REMARKS

Reconsideration of all grounds of objection and rejection, and allowance of the pending claims are respectfully requested in light of the above amendments and the following remarks. Applicant has carefully reviewed the Office Action and responds as follows:

FIG. 4

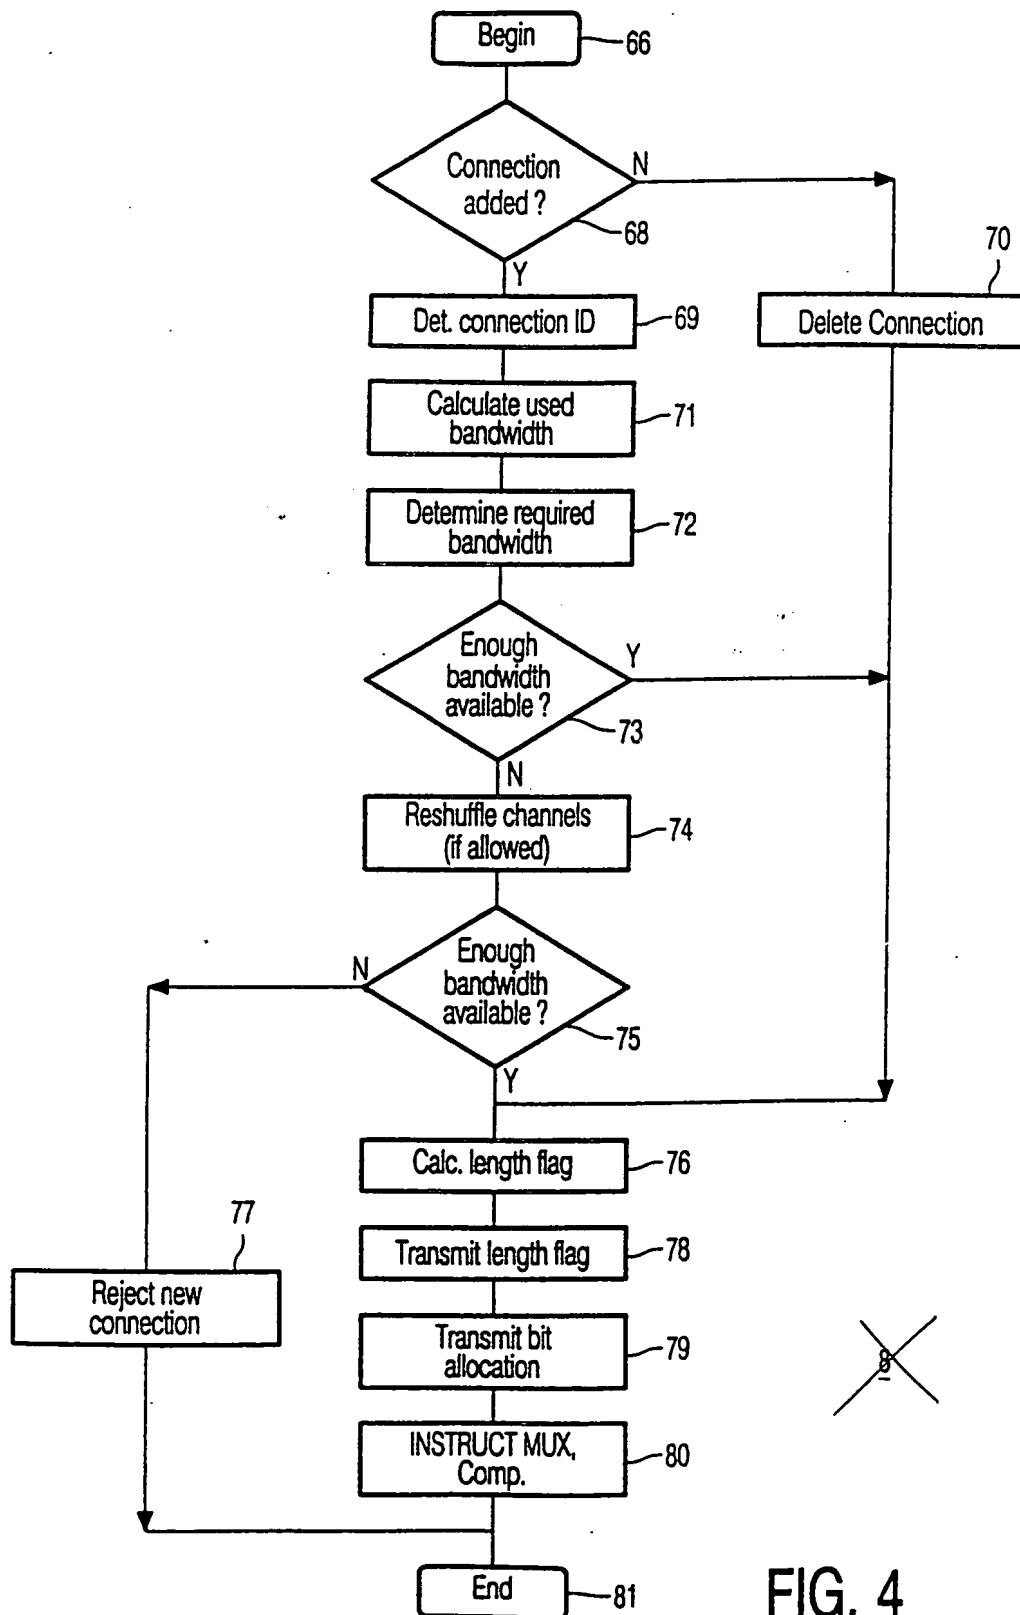
Applicant has corrected specification to include the reference, as required by the Office Action, in FIGs. 3 and 4. Applicant has also included a new FIG. 4, deleting the reference sign 8, as required by the Office Action.
